City of Sebastopol Design Review Board Staff Report

Meeting Date: August 19, 2020
Agenda Item: 7A
To: Design Review Board
From: Alan Montes, Associate Planner
Subject: Sign Permit and Sign Exception
Recommendation: Denial of Sign Exception and Conditional Approval of Sign Permit
Applicant/Owner: Fastsigns/Exchange Bank
File Number: 2020-048
Address: 840 Gravenstein Hwy North
CEQA Status: Categorical Exemption: Section 15311: Class 11
General Plan: Commercial Office (CO)
Zoning: General Commercial (CG)

RECOMMENDED FINDINGS OF DENIAL
Sign Exception
840 Gravenstein Hwy North
File #2020-048

RECOMMENDED CONDITIONS OF APPROVAL
Sign Permit
840 Gravenstein Hwy North
File #2020-048

① Dimensions for illuminated signs (Q=3).
scale: NTS

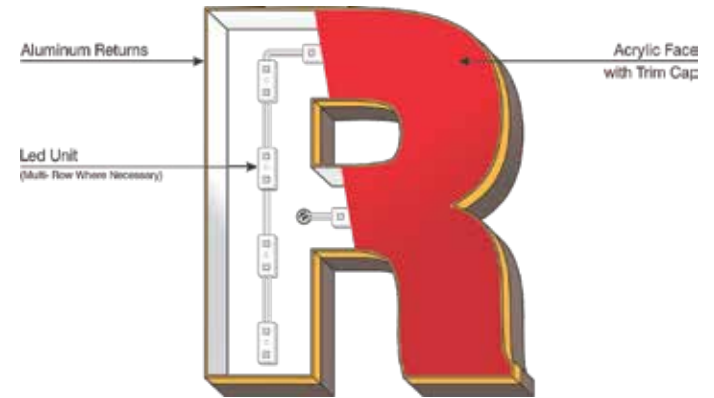
Staff has concerns regarding the proposed internal illumination for the signs. The Sign Ordinance is rather explicit in that internal illumination is discouraged and that external illumination is preferred. Staff also has concerns with having internally illuminated signage facing a residential neighborhood, as the light source would be directed towards the residences. overall, staff would discourage the use of internal illumination in general and explicitly for the signage facing the residential district. Staff has contacted the applicant regarding preferred alternatives and the applicant had stated "halo or externally lit such as goose beach or up lit" would be acceptable alternatives should the preferred option, internal illumination, not be

Staff does not believe that the addition of a third sign adds to the architecture or development of the site. As the building is designed for a single tenant, having a third sign in the parking lot in order to mark the entrance for clients is creating unnecessary redundancy, given that that is the only public entrance. If this signage is critical the applicant can allocate one of the two signs to this location.

Staff believes that granting of this exception would be a granting of special privilege as the City has not permitted a third wall sign for any of the other buildings in this vicinity. Additionally, as this is a single tenant building with a single entrance this has potential to create a precedent.

2. This approval permits the 18.67 sq. ft. sign facing Gravenstein Hwy N. and the 13.67 sq. ft. sign facing Tocchini St. This approval does not permit the 13.67 sq. ft. sign facing the parking lot (west).

3. The signs shall be a reverse pan channel letter sign (the face of the sign will not let light shine through the sign) with 2700K illumination.
4. An Encroachment Permit may be required prior to installation of the sign. Please contact the Engineering Department prior to installation if work will be performed, or materials placed, in the public right-of-way. The phone number for the Engineering Department is (707) 823-2151.
